Village of Cottage Grove

## PLAN COMMISSION

**RE:** **Atwell Suites Hotel – Precise Implementation Plan**

**Precise Implementation Plan Comments:**

**ATWELL SUITES**  
**SITE PLAN**  
 VILLAGE OF COTTAGE GROVE, DANE COUNTY, WI  
**SNYDER & ASSOCIATES, INC. |**  
 5010 VOGES ROAD  
 MADISON, WISCONSIN 53718  
 608-838-0444 | www.snyder-associates.com

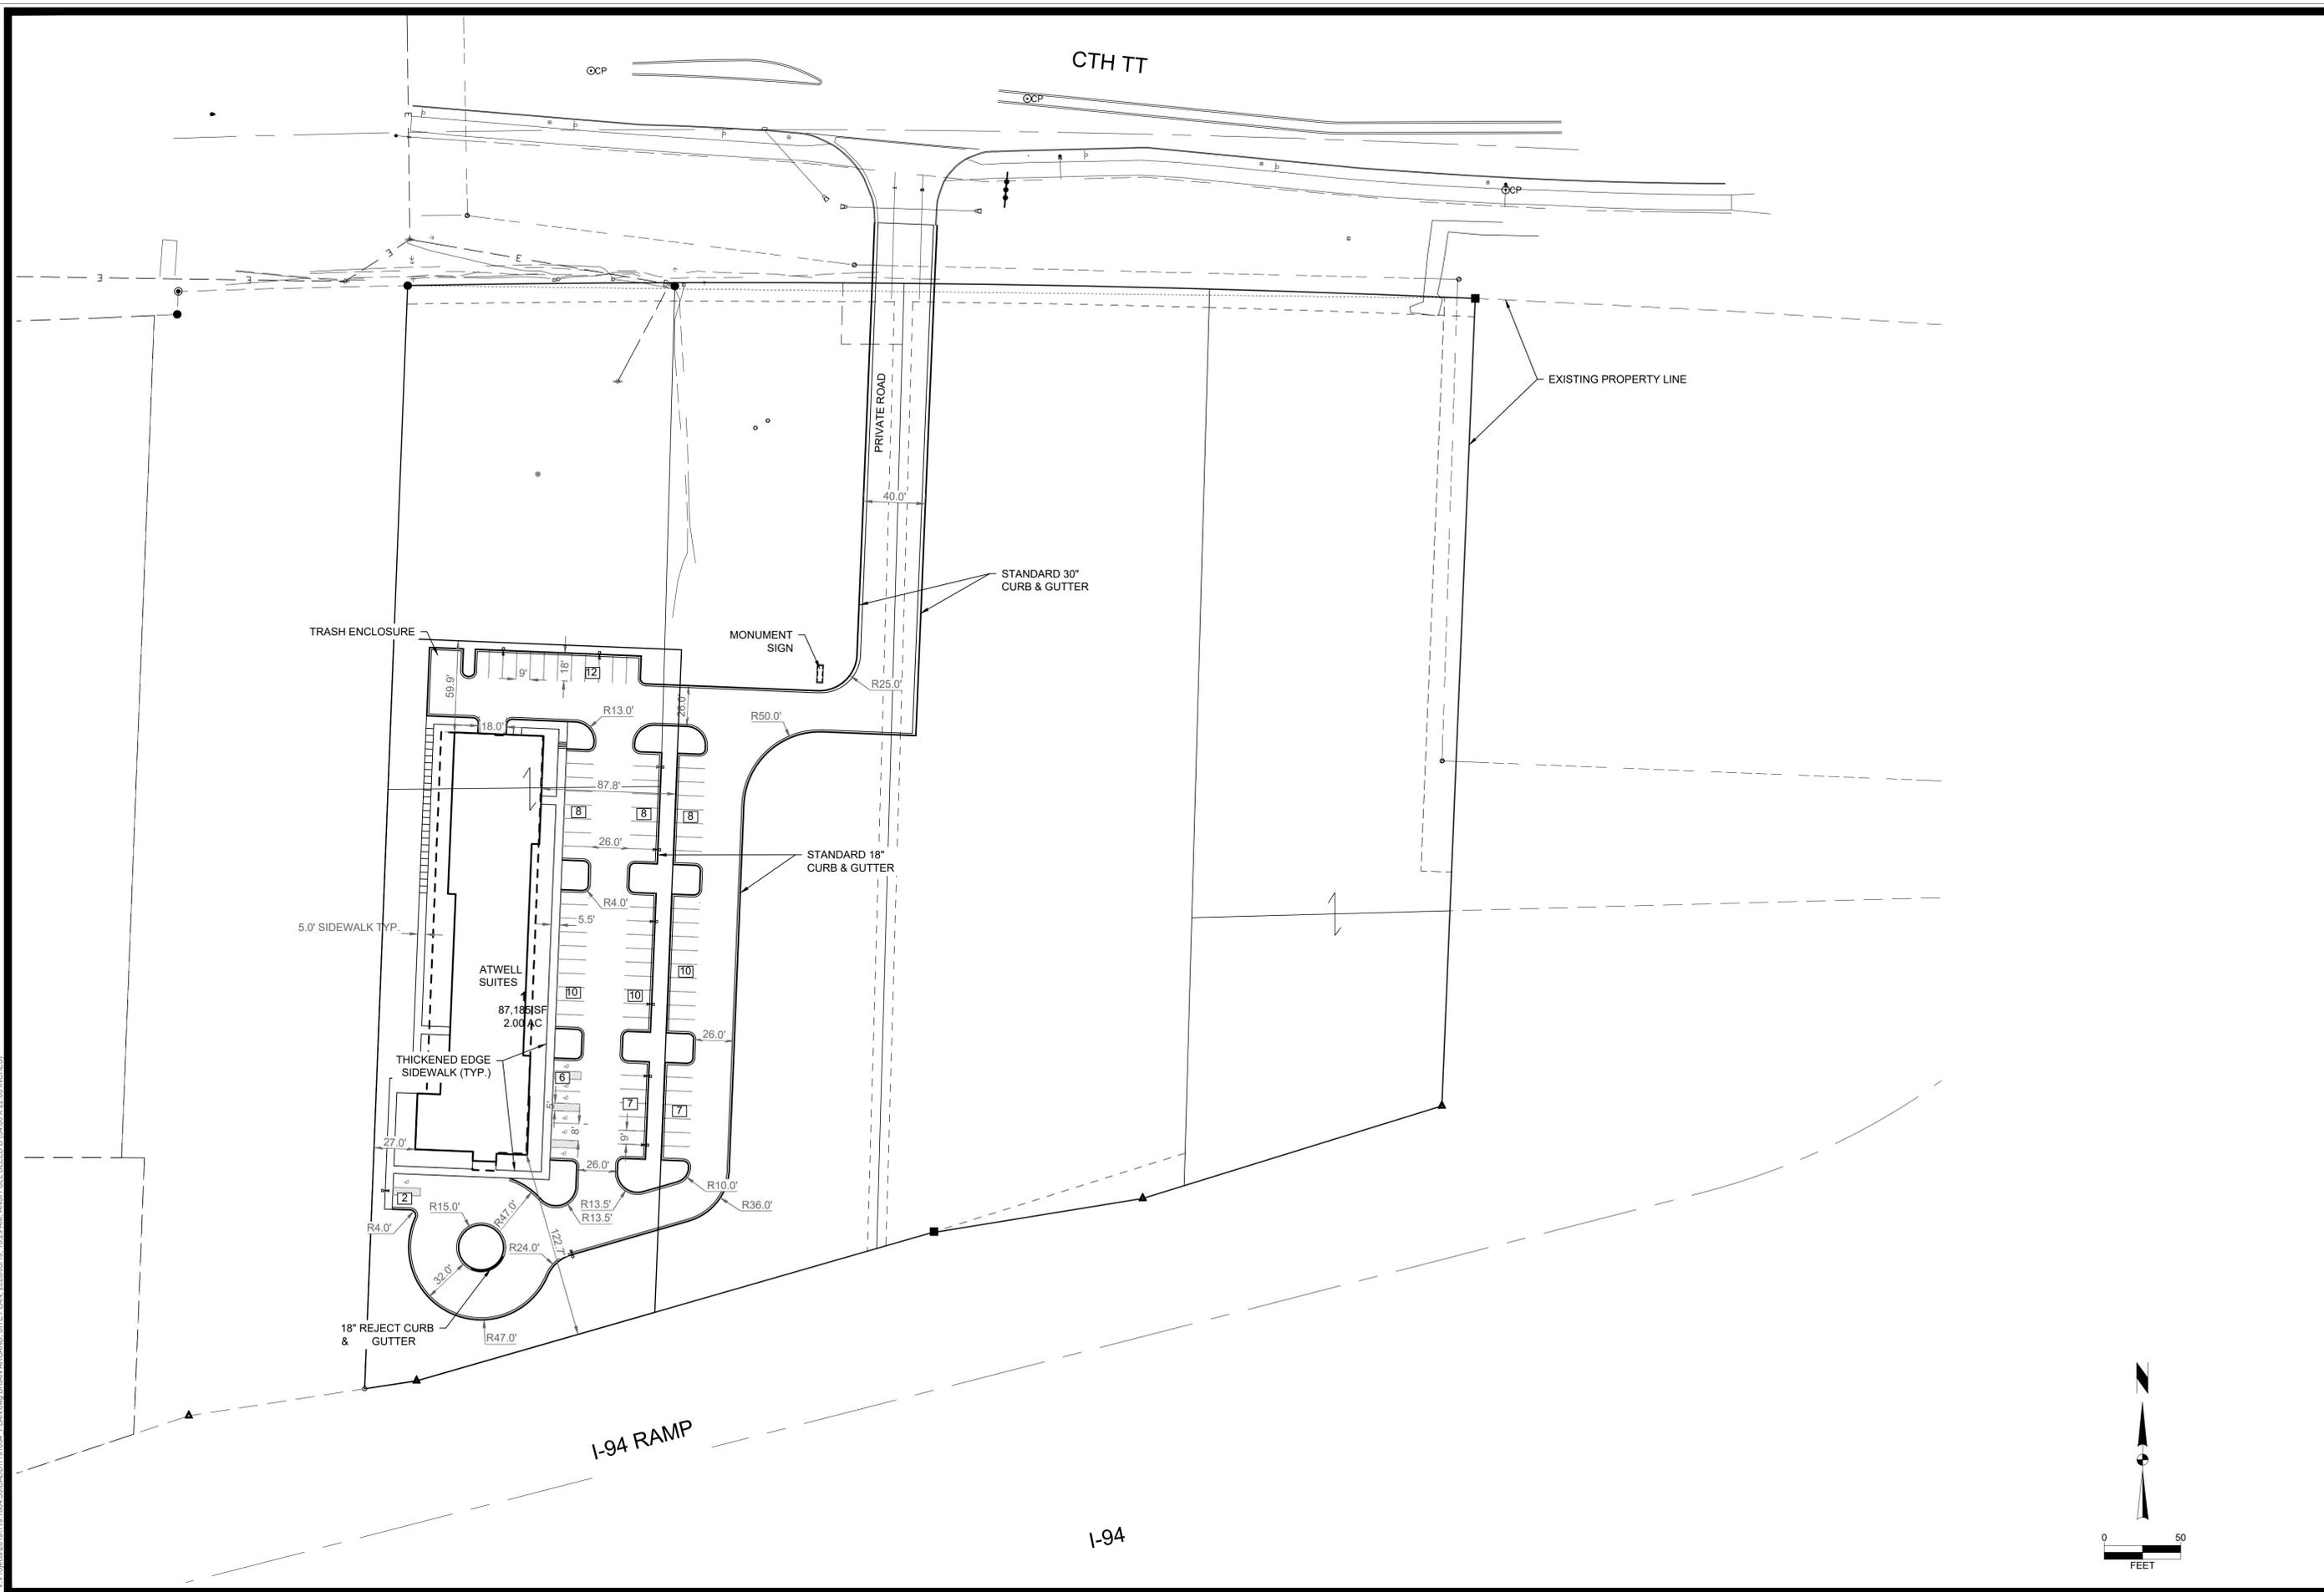
1. Show proposed lot lines for the site to verify and shared amenities or setback concerns.
2. It is assumed a CSM or plat will be prepared for the area to include the hotel and include the proposed stormwater either within the lot or in separate outlots or easements. Verify if any easements be necessary for a shared use of the underground stormwater facility.
3. Grading will be required on the parcel to the west of the property lines. Owner to secure an easement and/or permitting as necessary.

6. Verify trash enclosure can be accessed with gates when swung open and verify trucks turning around for exiting.
7. Lighting plan should be shown with proposed lot lines in order to verify trespass.

**ATWELL SUITES**  
**MULCH, SOD, & SEED PLAN**  
**COTTAGE GROVE, WI**

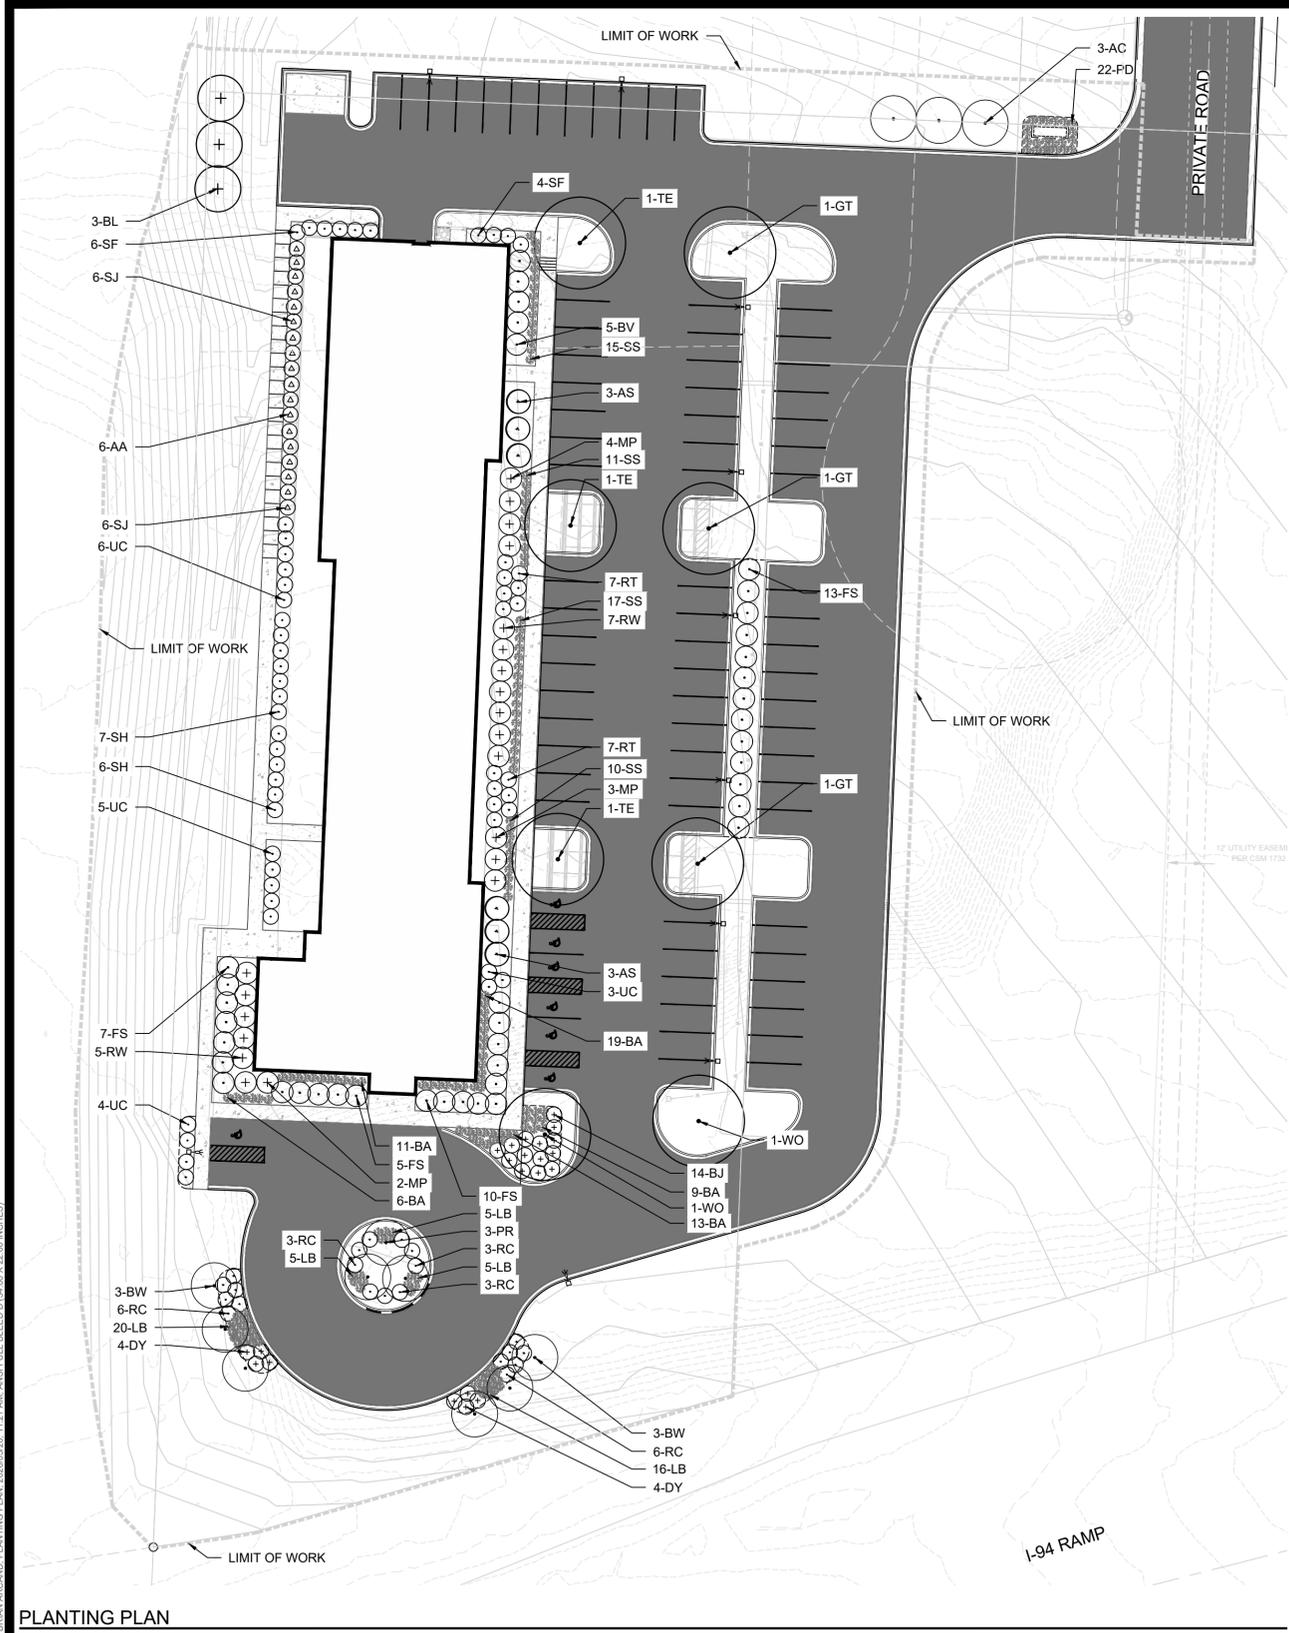
The landscaping plan shows a white oak near the SE corner of the building. Upon maturity white oaks can grow quite tall and as shown it appears that the tree may obstruct views of the building's signature southeast corner. The applicant may wish to consider relocating the white oak to a different location on the site.
